U.S. Department
Of Transportation
**Federal Highway
Administration**

Refer to: HNG-14/SS-43

Geometric and Roadside Design Acceptance Letter No. SS-43

Tie Down Engineering
VSAR Stud
10-14-92
Drawing No. MMBBS

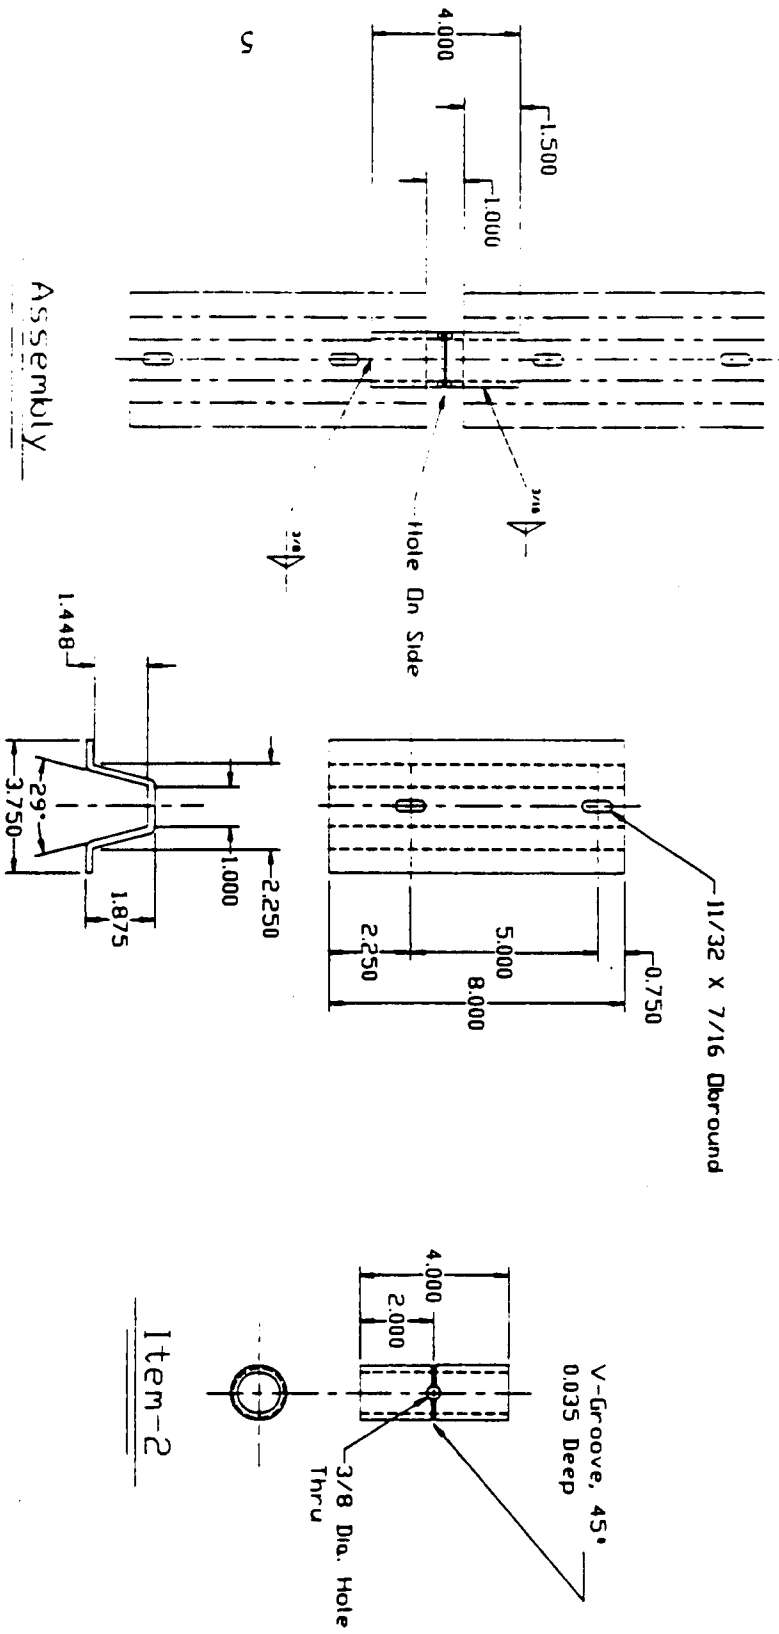
The device consists of two 203-mm sections of u-shaped channel (cold rolled by VSAR Systems, ASTM A569-B steel) connected by a 102-mm long, 38-mm diameter steel D.O.M. (seamless) pipe (ASTM A513 Type 5, 4.0-mm thick wall) welded into the valley of the u-shape. The ends of the u-shapes are separated by a 25-mm gap. The pipe is weakened in the middle with a 0.9-mm deep v-groove around the circumference and a 9.5-mm diameter hole drilled through both walls. Pendulum testing show that the holes drilled at right angles to the direction on head-on hits, are necessary to ensure fracture when the support is hit on the side. The device is shown in the enclosed drawing number MMBBS.

We concur in the assessment by Dean Alberson of TTI that the Speed-E-Rect will work with Franklin Steel U-Channel posts. It must be noted that the device must nest snugly in the valley of the U-channel post. The Speed-E-Rect was designed for use with Marion Steel posts, and a spacer is required when used with Franklin Steel posts. In either case, the bolts are drawn tight to assure that the device nests with the sign support and stub.
